Enclosed are two of the Department of Energy/Sandia National Laboratories, New Mexico response to the July 31, 1997, Notice of Deficiency (NOD) for the Technical Areas III and V RCRA Facility Investigation Report.

**Sandia National Laboratories
Environmental Restoration Project**

Comment Responses

**Notice of Deficiency July 31, 1997
Results of the Technical Area III and V RCRA Facility Investigation
Submitted to EPA and NMED June 1996**

ATTACHMENT 3
Chromatogram of Mineral Oil from TA-III/V sites
MSDS for Shell Diala AX™ Oil

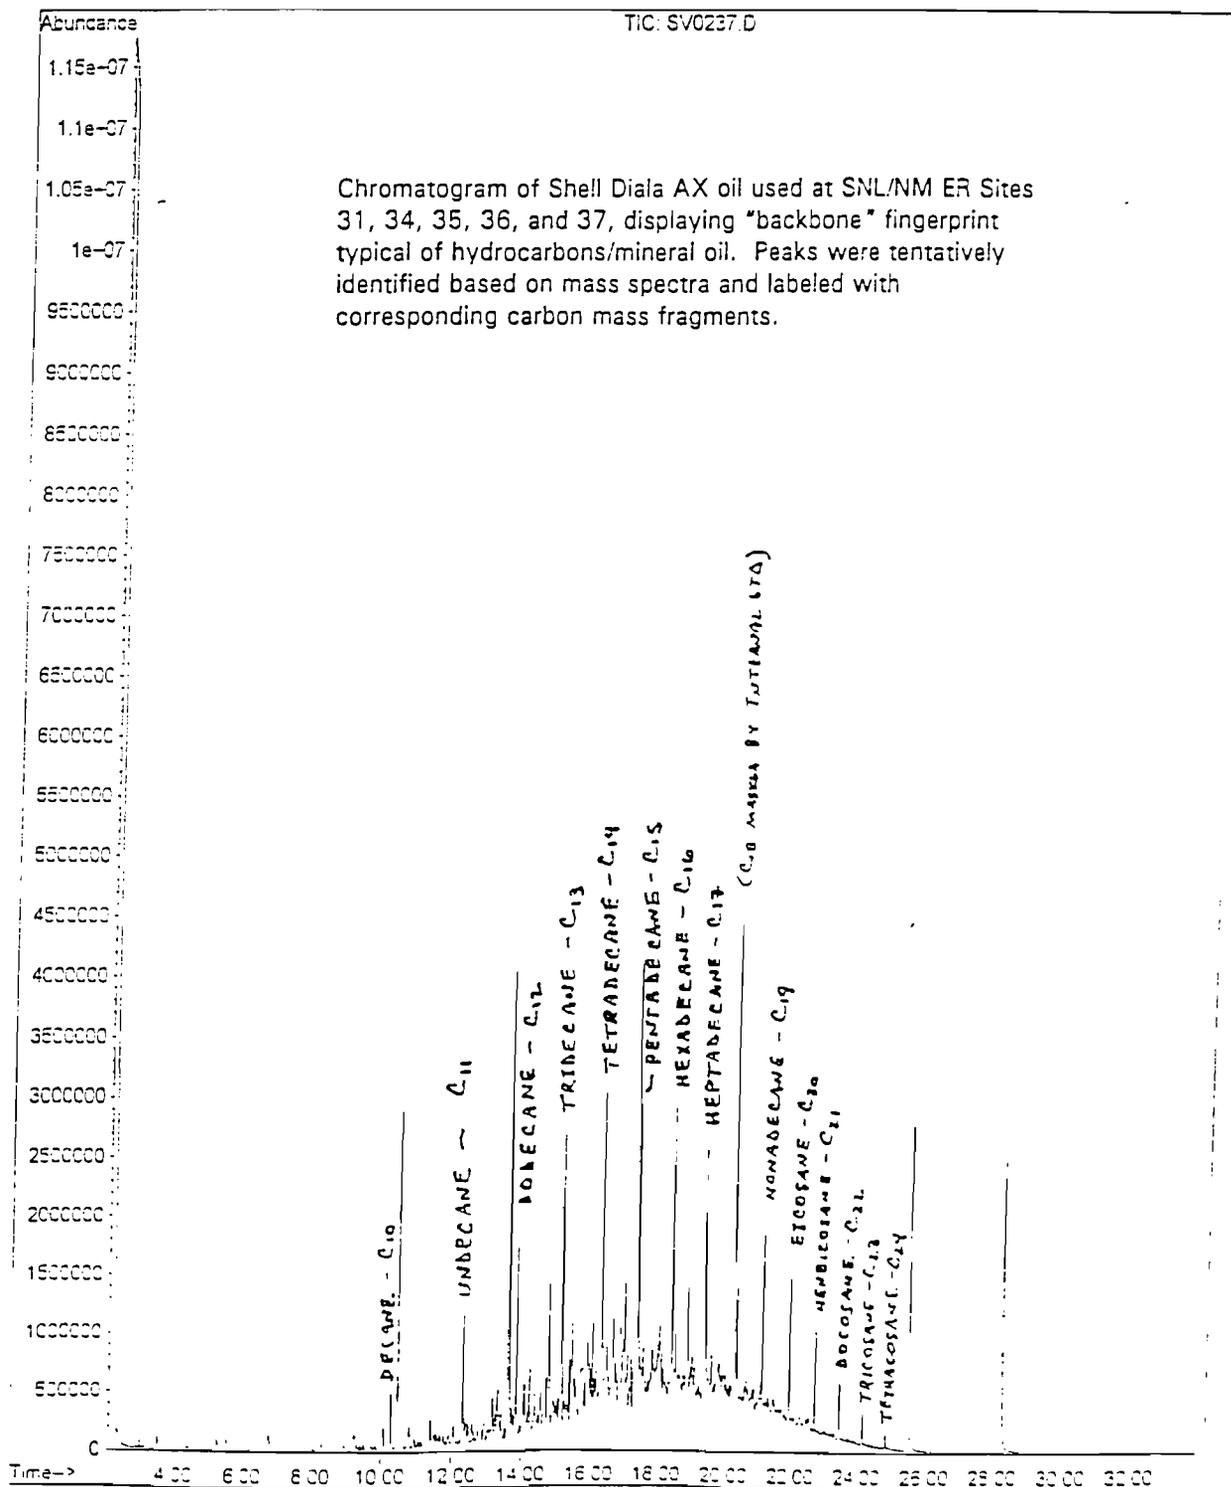
DOE and SNL/NM do not believe that the cistern poses a threat to groundwater for two reasons: 1) the mineral oil used in the cistern does not contain any hazardous constituents as manufactured (see Response to Comment 7 and Attachment 3), and 2) the extent of impact is not believed to reach groundwater, given the fact that the neighboring site, Site 36 (HERMES) was impacted by much greater volumes of oil, and the oil has been demonstrated to cease approximately 300 feet above groundwater. DOE and SNL/NM do not believe additional sampling is warranted, based on these reasons and on those listed in Responses 5, 7, and 32. However, DOE and SNL/NM agree that further discussion is needed to resolve Comment 31 and is looking forward to resolving issues regarding this site. Topics of discussion should include a determination of regulatory guidelines on mineral oil (the primary COC at the Site 196) and its byproducts.
